# **SuDS and Drainage Report**

**Land east of Commonmead Barn, Pagham Road, Pagham,  
West Sussex PO21 3PY**

**Rev: P5**

**Ref: C3552**

| DRAWING TITLE | DRAINAGE LAYOUT                     |             |            |

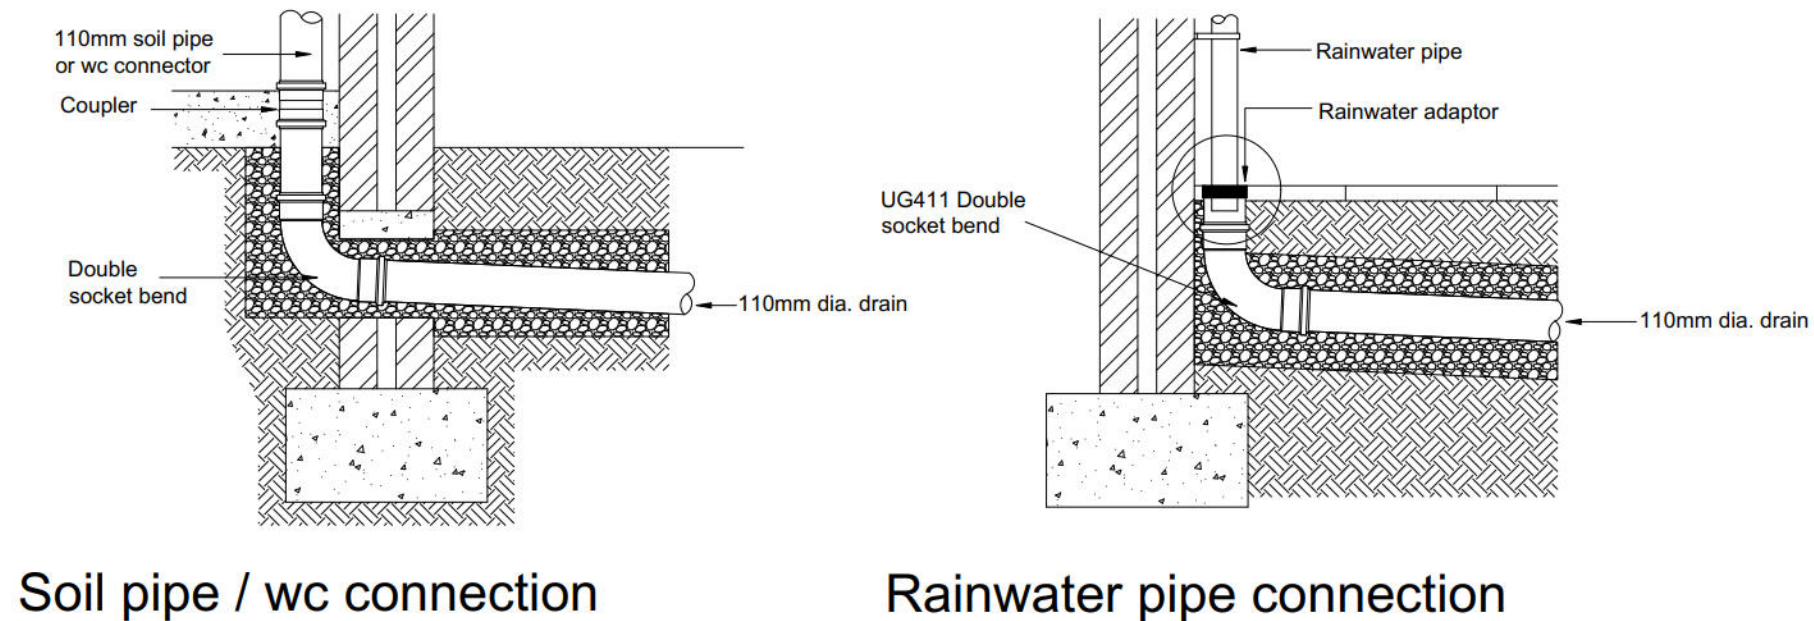
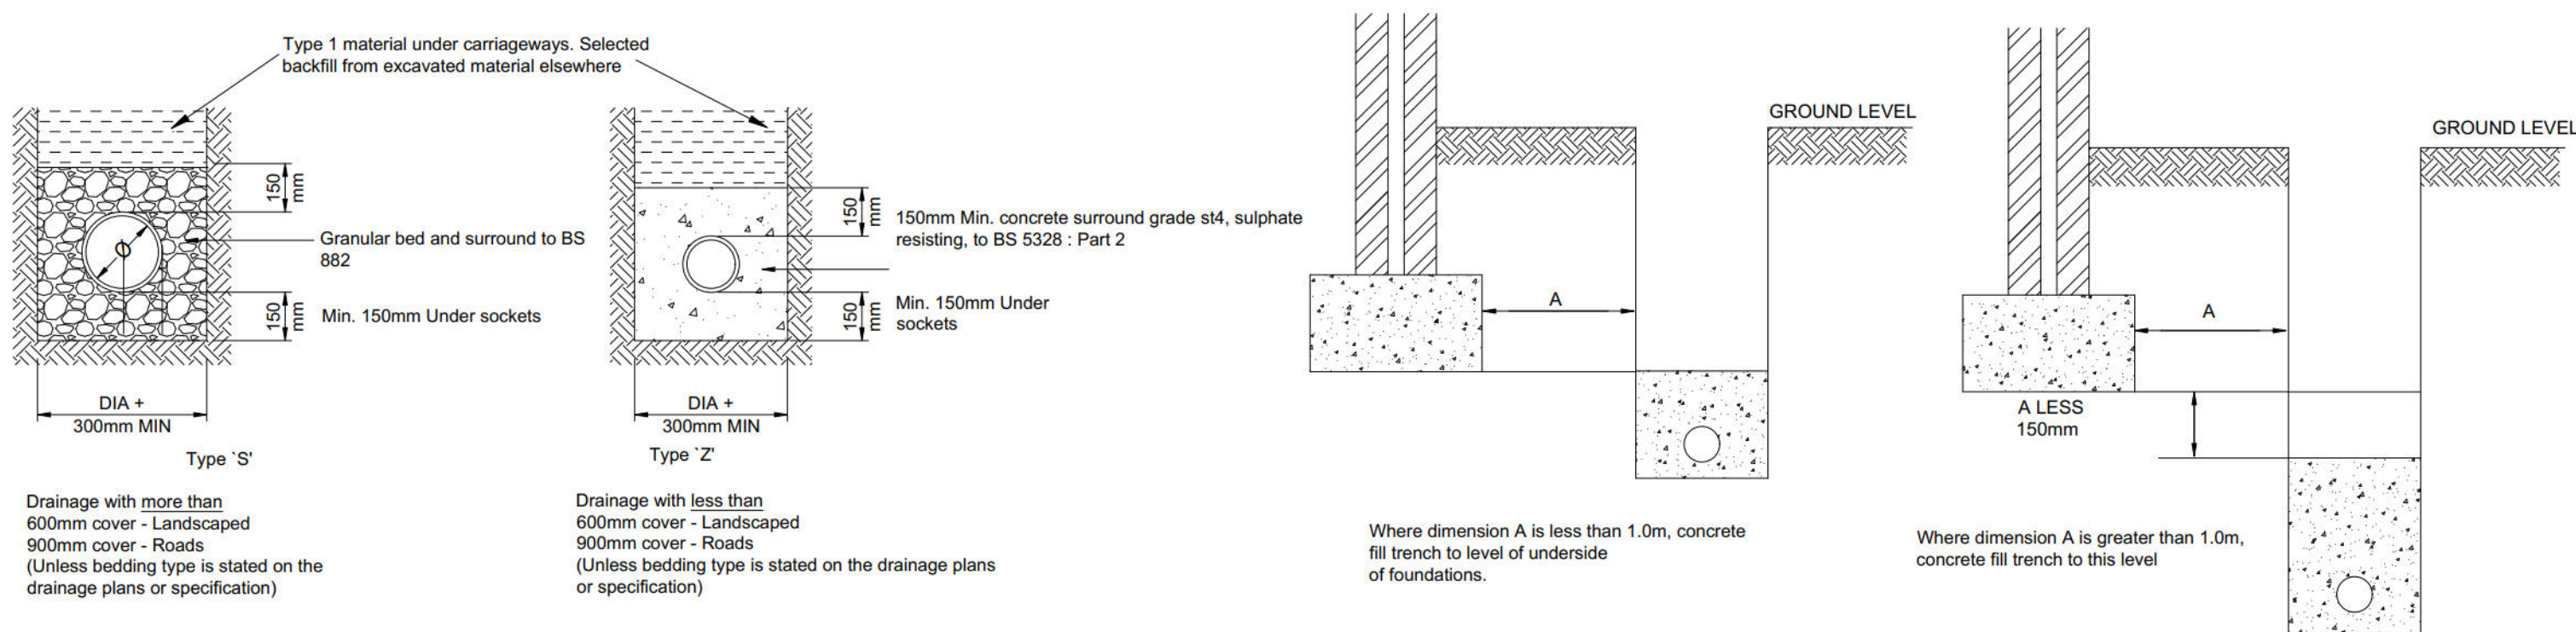
1.2. The 3m easement for the culverted watercourse should be shown on the plans and may conflict with the proposed building location.

2.1. Interception drainage is currently provided by bio retention installations and permeable paving, however, once the design is altered to remove infiltration within 1 metre of groundwater, measures to include interception drainage will need to be added.

3.3. A drained areas plan should be provided. It is noted that the urban creep allowance is incorporated into the model simulations.

3.4. The infrastructure within the permeable paving storage may reduce the available capacity and any significant chambers and any utilities margin should be removed from the plan area / volume calculation.

1. Runoff destination - Discharge to culverted watercourse proposed. No infiltration included. 3m easement is shown on plans – runoff destination is in accordance with NSfS

2. Interception drainage – Interception still provided by means of bioretention planets and permeable paving, in addition to rainwater harvesting all of which is in line with NSfS and Arun DC policy.

3. Extreme rainfall and flooding – We've removed infiltration from all features as required and also reduced the discharge rate from 1.0 l/s to 0.5 l/s per plot. This is a slow as can be practically achieved whilst ensuring self-cleansing velocity within the network. NSfS dictates that discharge rate should be restricted to greenfield runoff or 3l/s/ha whichever is greater. Unfortunately, in this case, both are unachievable with greenfield runoff having a QBAR of 0.1l/s and the 3l/s/ha results in a discharge of 0.4l/s for the site. A drained areas plan has been supplied within Appendix B.
